From: "Semborski, Chuck" <chuck.semborski@pacificorp.com>
To: "'petehess@utah.gov'" <petehess@utah.gov>, "'Jim Smith'" <JIMDSMITH@utah.gov>, "'Priscilla Burton'" <PRISCILLABURTON@utah.gov>
Date: 3/27/03 3:35PM
Subject: Des-Bee-Dove Phase 2 Change Order #2

**DES-BEE-DOVE MINE
PHASE 2 RECLAMATION
Change Order Chronology**

Change Order #2

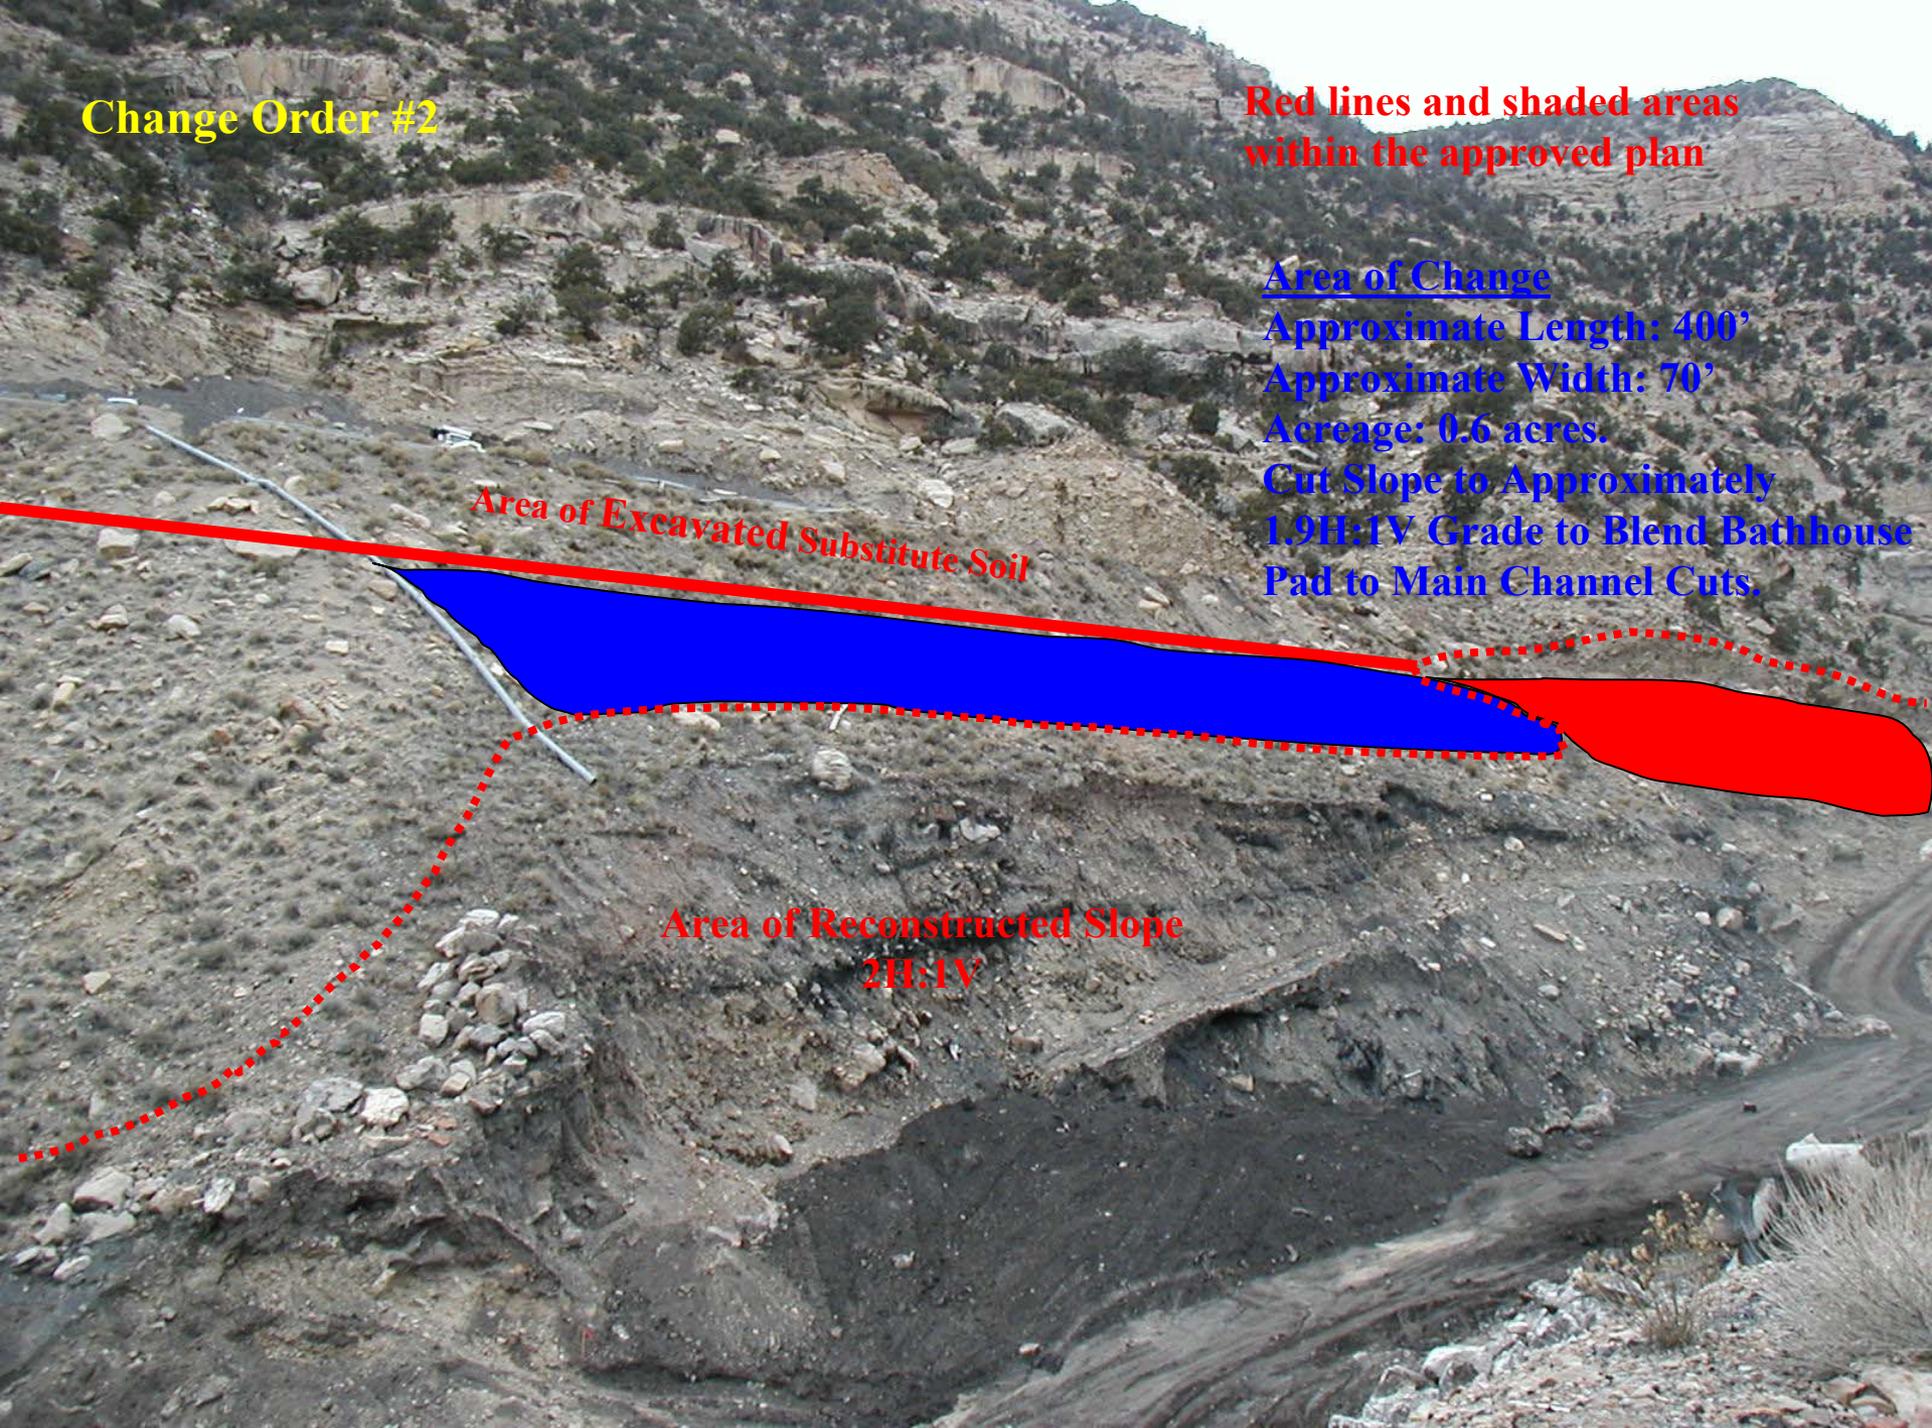
Red lines and shaded areas within the approved plan

Area of Change

Approximate Length: 400'

Approximate Width: 70'

Acreage: 0.6 acres.

Cut Slope to Approximately 1.9H:1V Grade to Blend Bathhouse Pad to Main Channel Cuts.

Area of Excavated Substitute Soil

**Area of Reconstructed Slope
2H:1V**
